LARAMIE COUNTY PLANNING & DEVELOPMENT DEPARTMENT

MEMORANDUM

TITLE: Review and Action on a Minor Subdivision Permit and Plat for “Captain Soltierra” subdivision, located in a portion of Section 30, T15N, R62W, of the 6th P.M., Laramie County, WY.

PZ-26-00014 CAPTAIN SOLTIERRA,
A MINOR SUBDIVISION PERMIT
AND PLAT

CAPTAIN SOLTIERRA

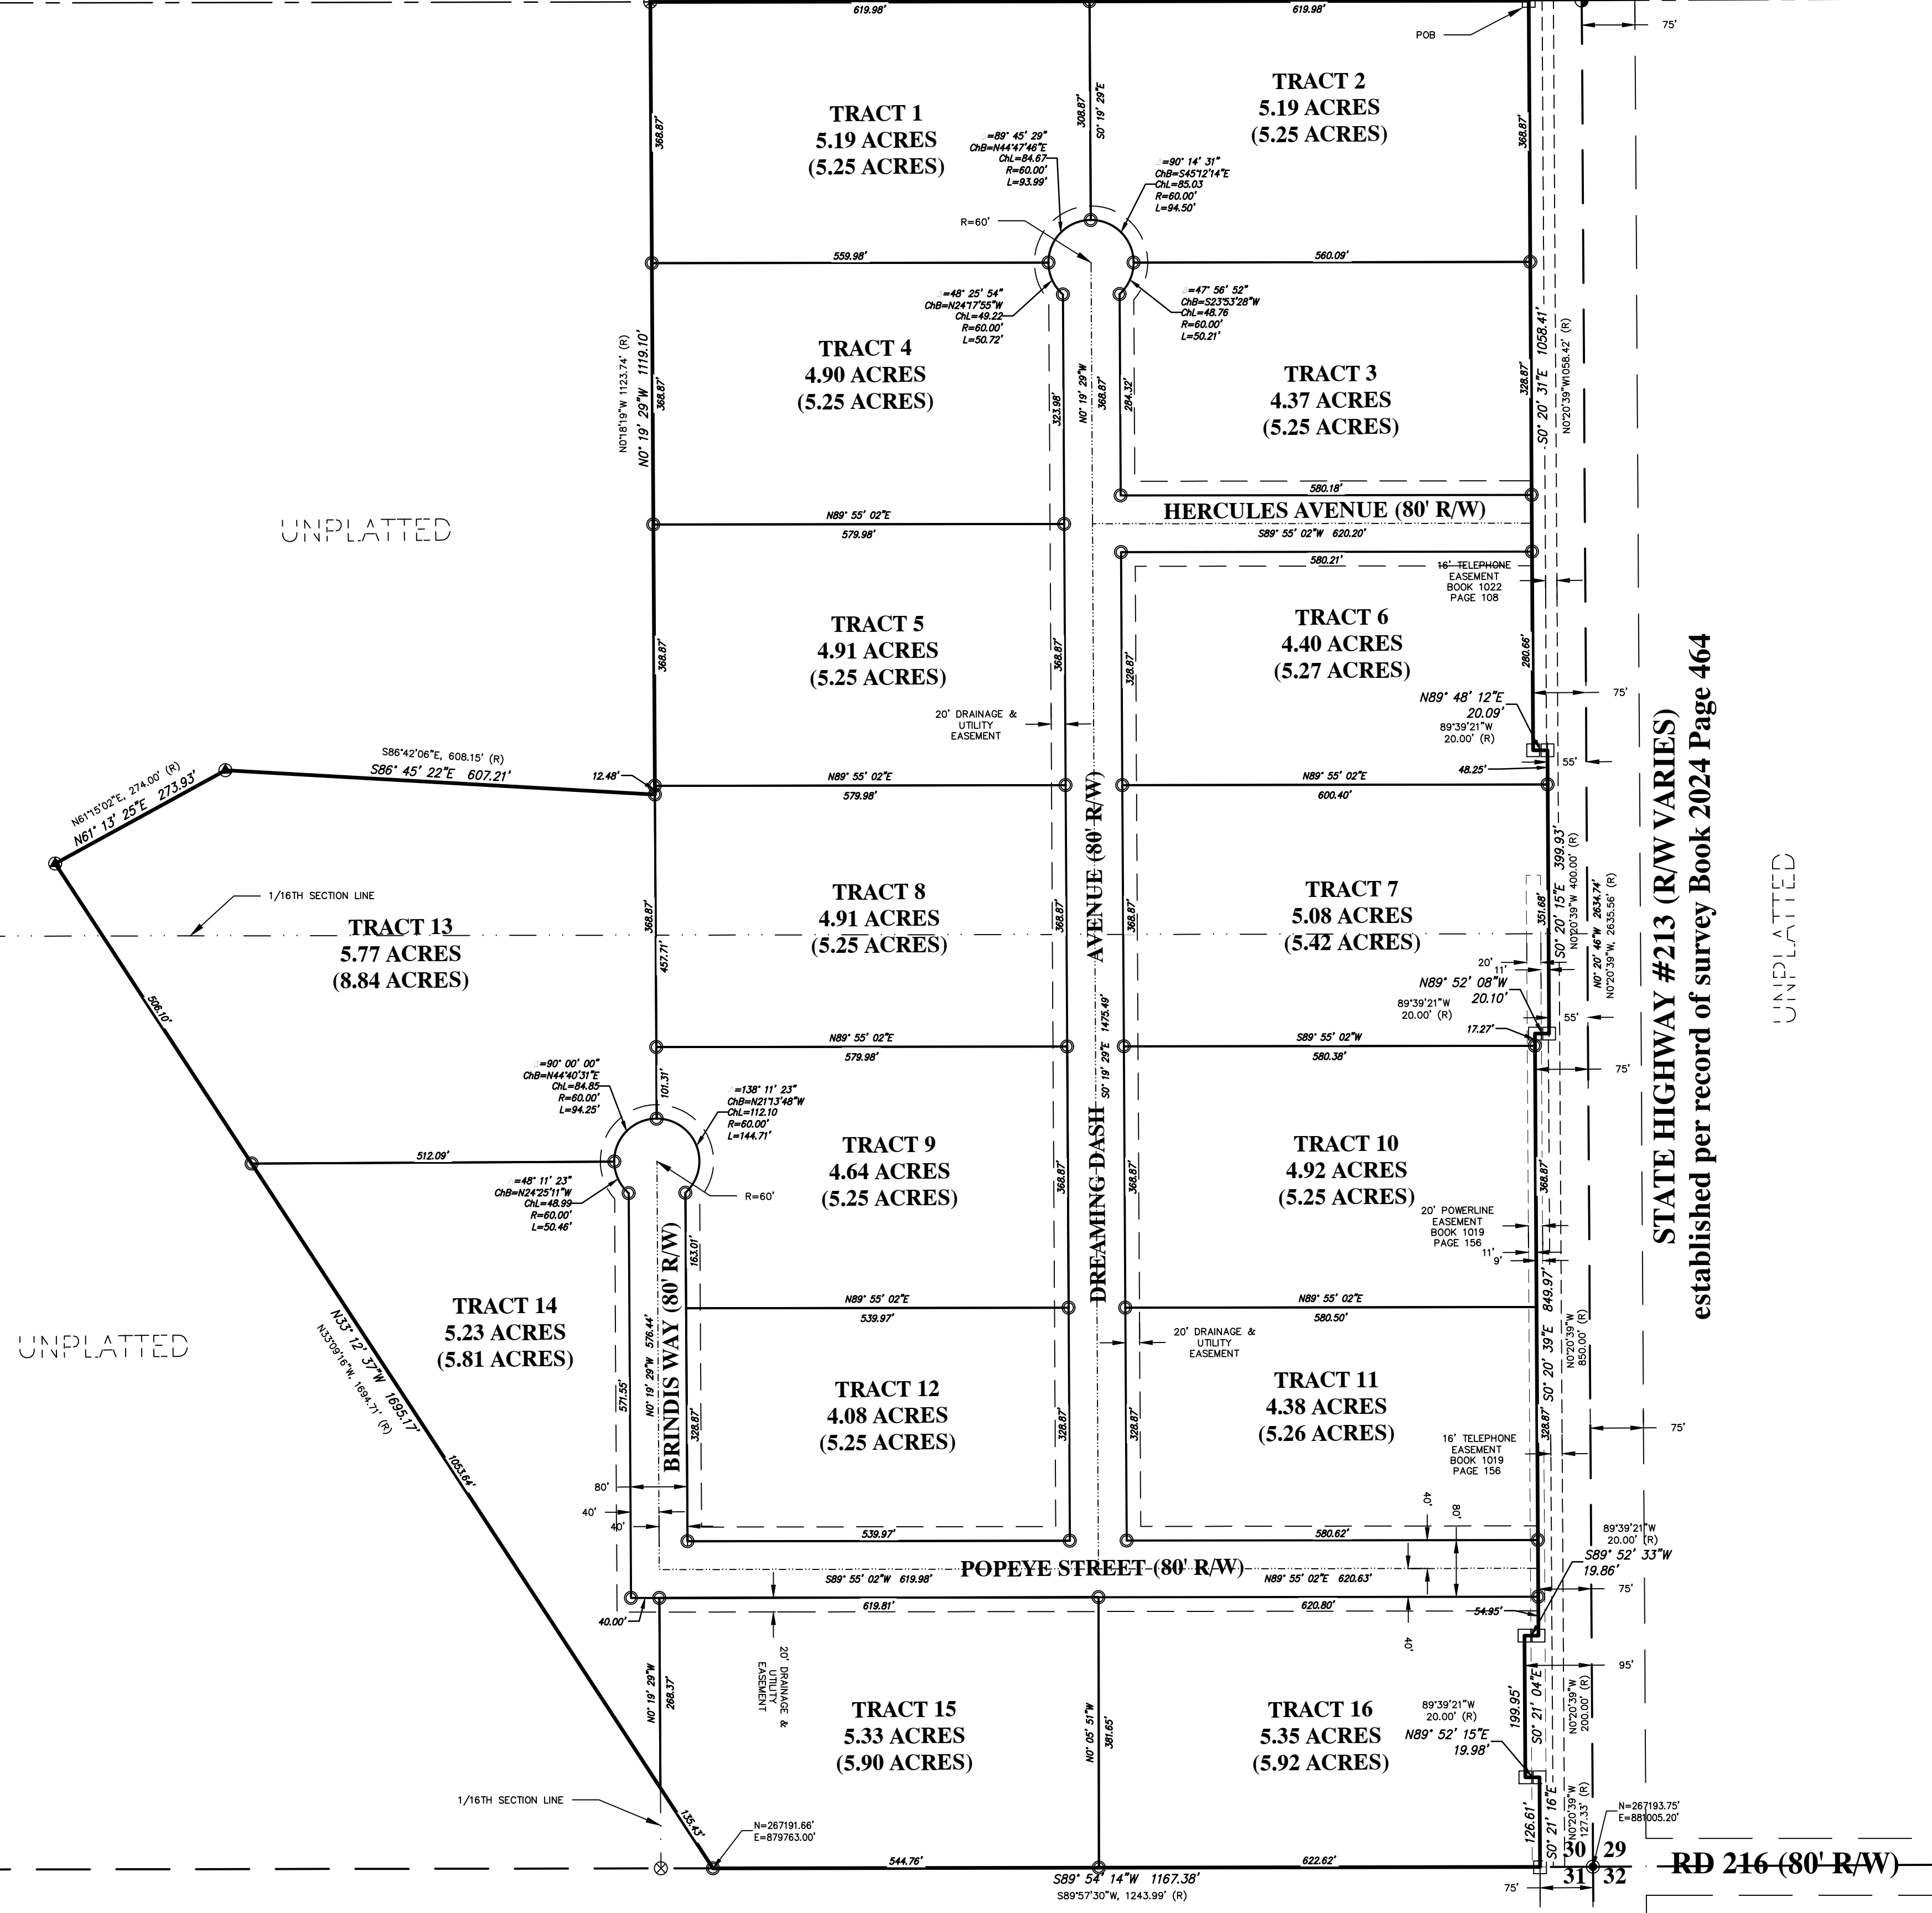
03/19/2026	03/19/2026	Workflow	COUNTY REAL ESTATE OFFICE REVIEW	DEFICIENCY	Please double check the spelling of the owner's first name...that Ramiro is spelled with an A on the plat map. The Owner Acknowledgement has it spelled as Romiro with an O. Otherwise, no other comments.	RACHEL.TRUDEAU@LARAMIECOUNTY.WY.GOV
03/24/2026	03/24/2026	Application	PZ-26-00014	GENERAL	No Comments	MATTHEW.BUTLER@LARAMIECOUNTY.WY.GOV
03/26/2026		Application	PZ-26-00014	GENERAL	Applicant shall address agency comments.	JUSTIN.ARNOLD@LARAMIECOUNTY.WY.GOV
03/27/2026	03/27/2026	Workflow	COUNTY ASSESSOR REVIEW	GENERAL	No comments.	CINDY.KEMIVES@LARAMIECOUNTY.WY.GOV
03/30/2026		Workflow	ENGINEERS REVIEW	GENERAL	1st Review Engineers Comments: 1.In the title block, it is called out as a Large Subdivision, however, under the LCLUR it is classified as a Minor Subdivision. 2.The owners name is listed on the plat as "Romiro", but the GIS and the Deed lists it as "Ramiro". Please verify which is the correct spelling. 3.Note 7 indicates "All Utilities to be placed in the road right of ways as required by Laramie County." This is not necessarily a requirement of Laramie County 4-5-103.xi. states, "All utility facilities, including but not limited to gas, electrical	SCOTT.LARSON@LARAMIECOUNTY.WY.GOV

4. There is a short boundary line segment between the northwest corner of Tract 8 and the northeast corner of Tract 13 that needs to be dimensioned.

5. A note should be added to the plat to indicate access to all Tracts shall be from internal roadways and not off State Highway 213.

1. Per 5-2-102, there needs to be Wyoming State Plane field observation coordinates shown on the plat.

2. Since it is intended and required that all internal roadways (i.e., Hercules Ave., Popeye Street, Dreaming Dash Ave., and Brindis Way) be dedicated to the public, it should be stated on the plat for clarification.

- 1. corrected
- 2. corrected
- 3. added utility easements

- 4. added
- 5. added
- 6.ack

- 1. added
- 2. dedicated in the Dedication
